RMA 2017 3185

Woolworths New Zealand Limited

201 Halswell Road

**Land use and subdivision consent applications to establish a
residential and commercial mixed use development.**

Figure 2: Expected likely lateral spreading mechanisms in a future earthquake

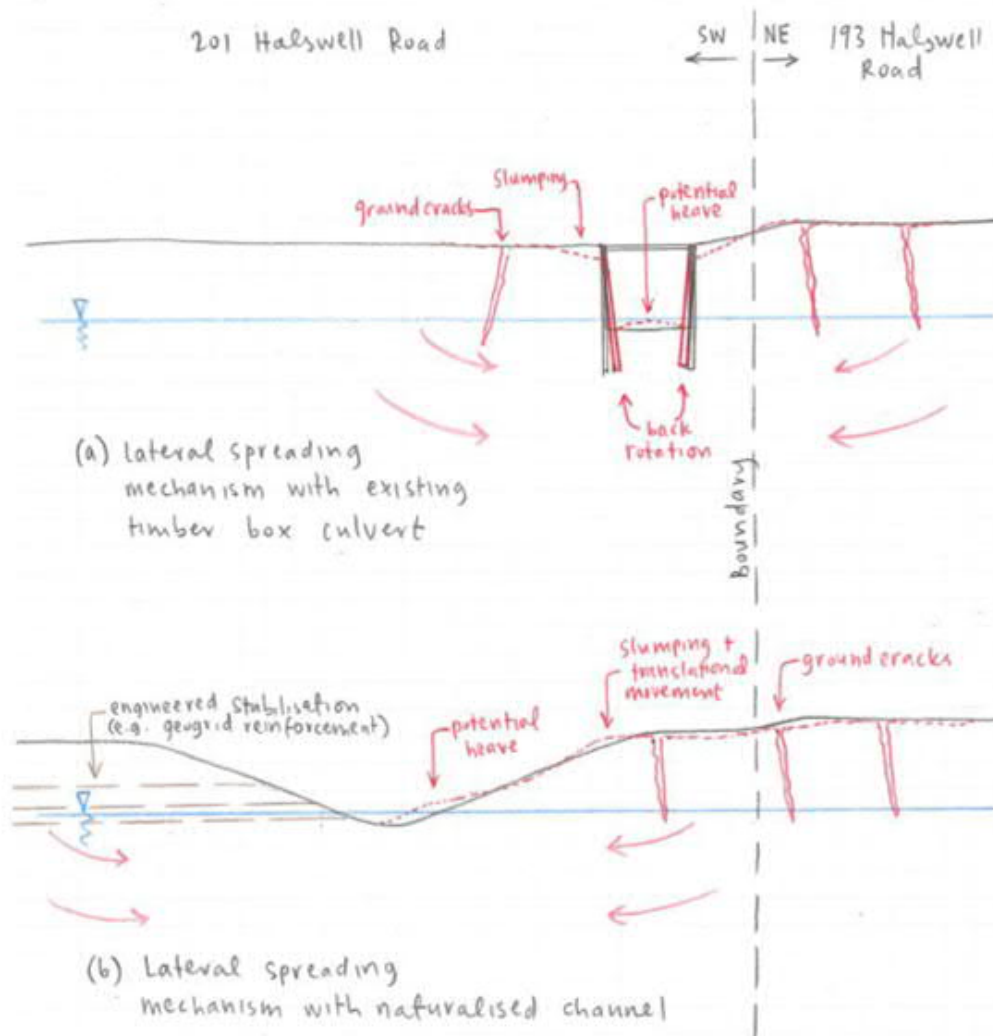
36. For the replacement of the timber drain with a naturalised drain at a 4.1m offset from the boundary, T&T have undertaken a section 106 assessment. They state that the likelihood of lateral spreading in the adjacent property is 'no different than it is currently'.

Figure 4: Reserve link to adjacent land

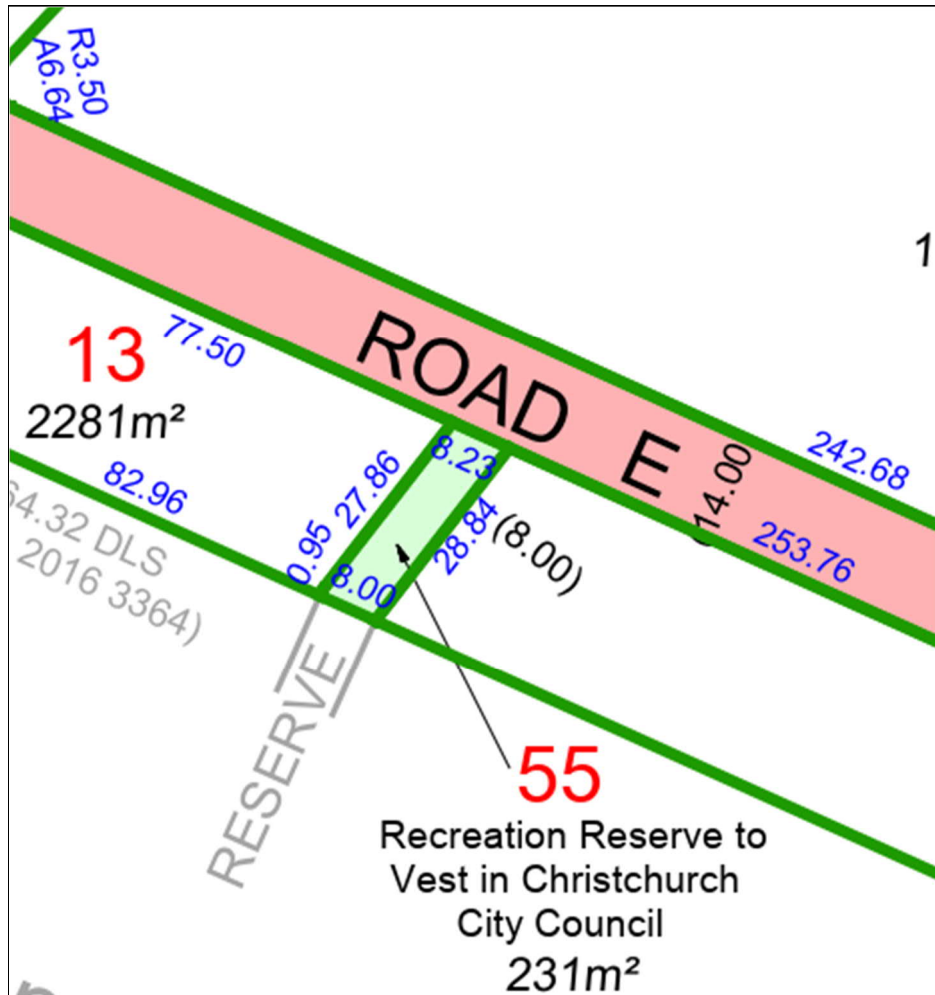
27. All internal roads will include 2 footpaths and the residential area is proposed to include shared space accesses and interlinking bridleways that will be available for public access through these blocks. The footpaths along the frontage of the commercial area will be constructed to be a minimum width of 2.5 metres, as required by Council's IDS.
28. There is an 8.0 metre pedestrian / cycle link from the approved Milns Estate subdivision, to the south of the proposed development, to be matched by a similar

width link to Road E. This has been agreed to by the applicant, and has been shown on the scheme plan prepared by Eliot Sinclair, #426862, C1, Sheet 6, Revision J. I note that the proposed alignment creates an awkward angle at the boundary (Figure 4) which may create CPTED issues and care will be required with the design of the link.

Figure 6: Alignment of Road F relative to the road in Spreydon Lodge land

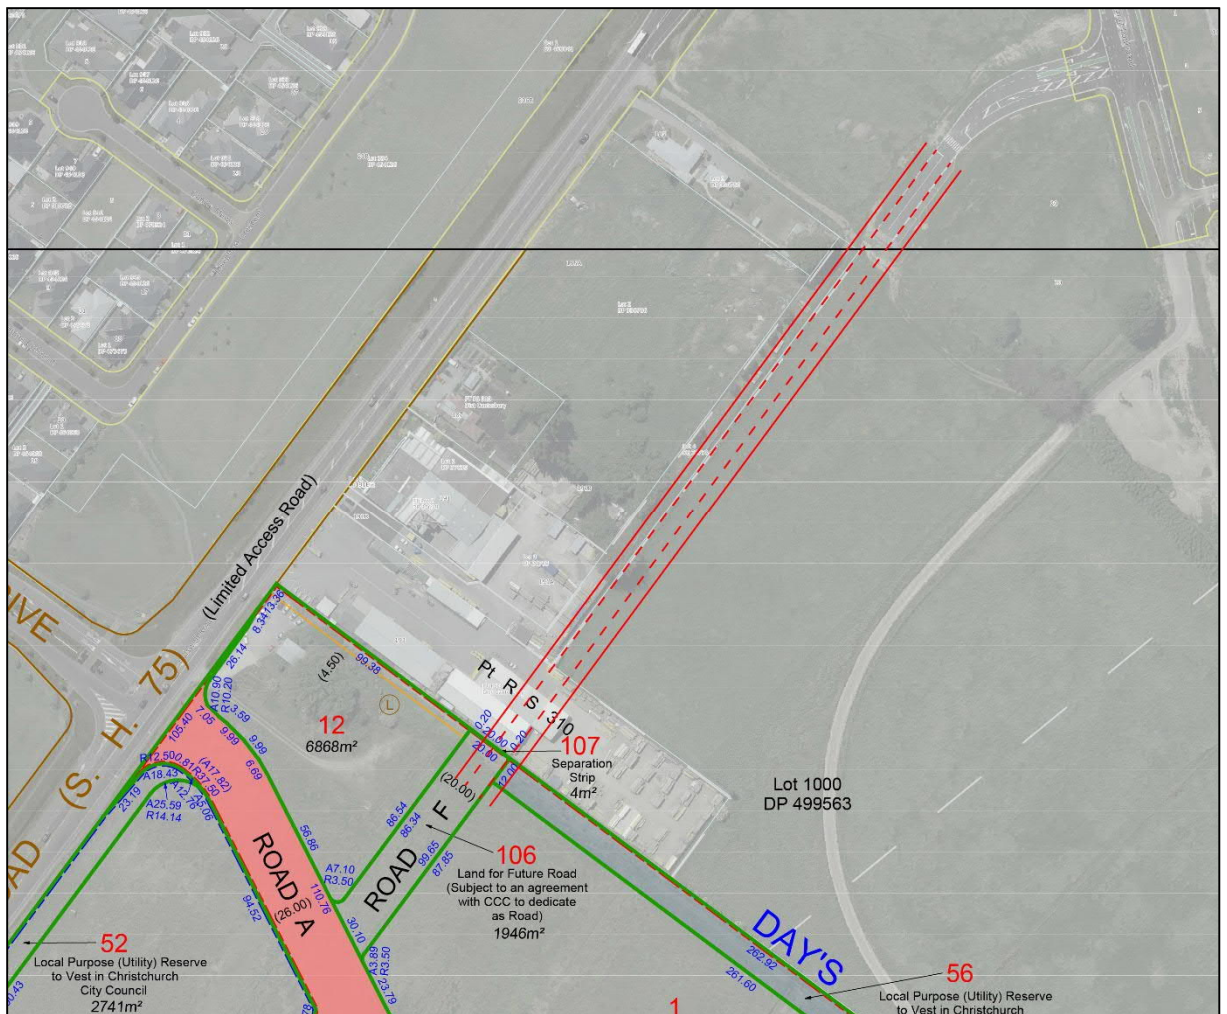
64. I note, however that the alignment of Road F at the boundary of the proposed development at 201 Halswell Road with the Halswell timber Company land does not align with the approved and constructed road within the Spreydon Lodge site. The alignment of proposed Road F is approximately five metres north-west of the alignment of the road constructed within the site to the north, as indicated in **Figure 6**. The alignment of either, or both, roads could be adjusted to ensure they meet, but the corridor owned by the Halswell Timber Company limit the realignment of the road in the Spreydon Lodge site until such time as the timber company redevelops or relinquishes the right of way. This currently leaves an awkward misalignment between the two sections of road that would require a further set of reverse curves to bring the two roads together on the same alignment. To avoid the need for a series of reverse curves I recommend that road F is realigned to line up with the constructed section of road within the Spreydon Lodge development.

45. *Figure 6: Walkable blocks shown over subdivision plan*

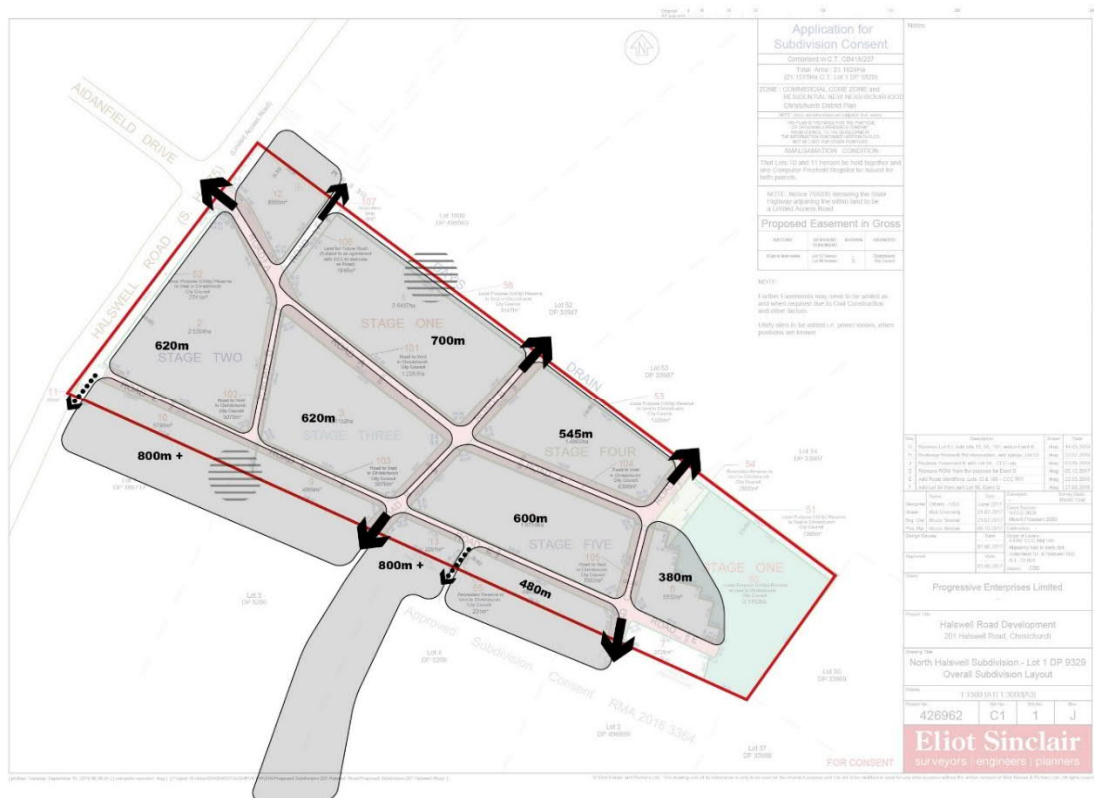
43. However, I consider that the key connection to the Main Street, the Green corridor, has not been adequately addressed as part of the overall subdivision pattern. The Green Corridor provides the connection to the Main Street of the northern area of the ODP. The Main Street is a key design and commercial component anticipated for the KAC

which I already identified in regard to the policy framework (15.2.2.2 b ii) and which is clearly pointed out in the matters of discretion for the North Halswell ODP (15.13.4.3.2 a i). I note that Mr Heath in his evidence in paragraph 39, has stated that a strong physical connection is imperative to ensure the economic success of the Main Street commercial offering. Furthermore, I consider that a direct physical and visual connection provides both the access and legibility required to promote an appropriate level of activity.

44. I do not consider the Green Corridor shown in the ODP to be part of the subdivision pattern as no land tenure arrangements are proposed to secure it through the subdivision consent application (such as a legal road, reserve or easement).

Figure 7: Misalignment of Green Corridor and Main Street between the two proposals

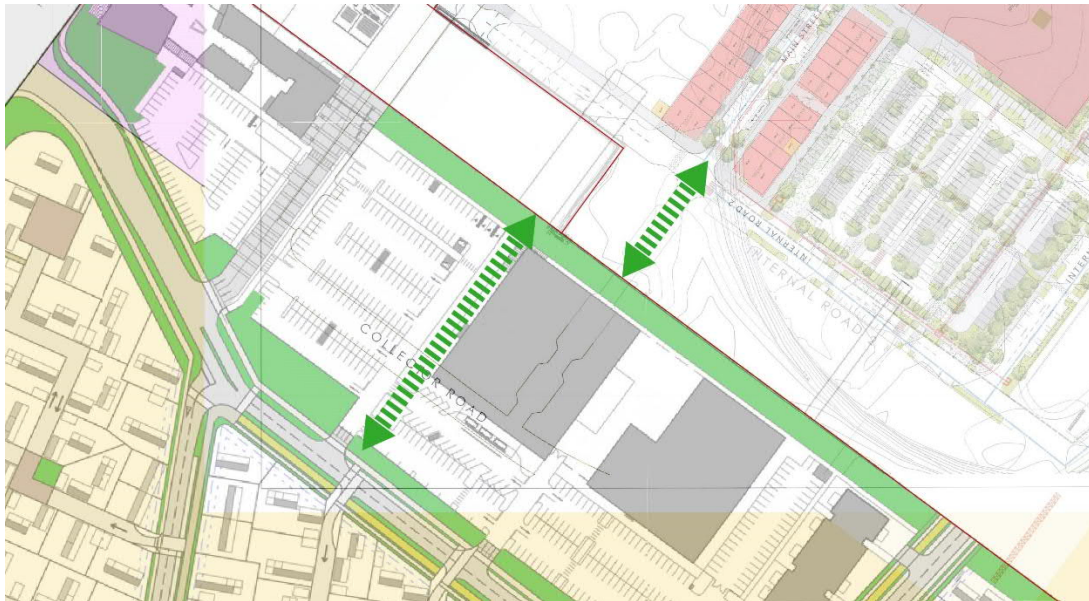
46. Within the commercial ODP, the green corridor aligns with the main street of the KAC. When observing figure 7 these do not align and the green link terminates further to the west at the Timber Yard boundary. Although the exact location of the open space link and Main Street can vary in alignment this will likely create connectivity issues within the near future. The complexity in this alignment is the property boundary of the timber yard

of Halswell Timber. If the Timber Yard is to remain operational for the foreseeable future the direct physical and visual connection with any future location of Main Street will not be achieved.
